Product Change Notification

1. ECN #: 243782

3. Series:

- TFM - .050 X .050 MICRO STRIPS
- TFML - .050 SHROUDED TERMINAL

TFM ASSEMBLY WITH "TAIL WITH" AND "TAIL WITHOUT" COIN

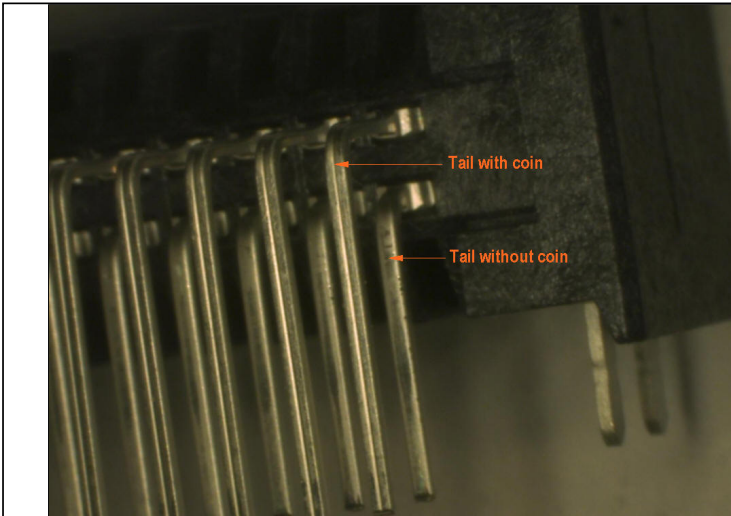
ADDED LONGITUDINAL COIN TO ONE SIDE OF TAIL TO AID STRAIGHTNESS

CUSTOMER CAN SEE WHAT APPEARS TO BE A SCRIBE LINE DOWN THE LENGTH OF THE TAIL ON ONE SIDE

EXISTING PIN WITHOUT COIN

REVISED PIN

COINING KEEPS THE TAIL STRAIGHTER, THIS IS A DESIGN IMPROVEMENT AND IS BEING IMPLEMENTED AS A RUNNING CHANGE, THERE COULD BE MIXED GENERATION PINS WITHIN THE SAME PART AND SHIPMENTS COULD ALTERNATE FROM EXISTING TO REVISED AND BACK TO EXISTING DEPENDING ON INVENTORY LEVELS OF THE SPECIFIC PINS INVOLVED.
